Appendix B – Public Engagement

Community Engagement

Nature of Liaison: The purpose and effect of the Notice of Application is to develop the subject lands resulting in a 142 unit apartment building, 4 storeys and 14.6m in height.

Re: Site Plan Application File No. 18-024
420 Fanshawe Park Road East

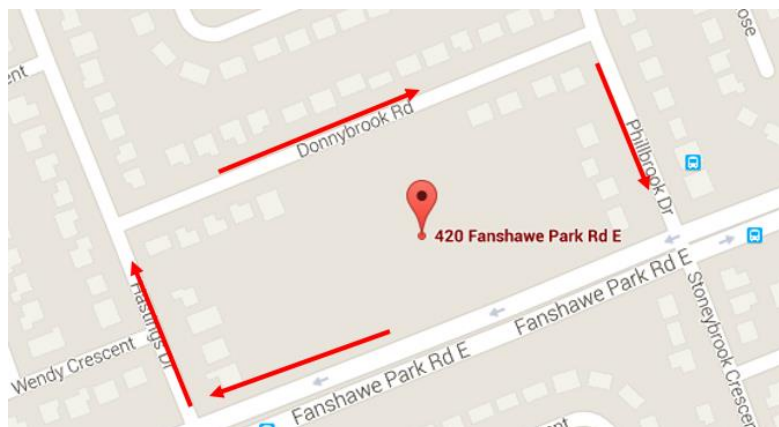
As a resident of Donnybrook Road, I continued to be troubled by the traffic implications of the proposed site plan. Donnybrook is already used extensively as an artery for the traffic light situated at the Fanshawe Park Rd. and Phillbrook Drive intersection. Traffic is significant and at times, rapid. This is currently an important concern in terms of the safety of my children as well as the other children and elderly residents of this street. The proposed site plan will consciously and significantly increase traffic on Donnybrook Rd, resulting in an even greater danger to residents of this community. Residents of the proposed building who will be unable to make left-hand turns onto Fanshawe Park Rd. to enter/exit will exponentially increase the dangerous flow of traffic on our residential street; Donnybrook Road will be used even more commonly as an artery to the traffic lights as per the diagram below.
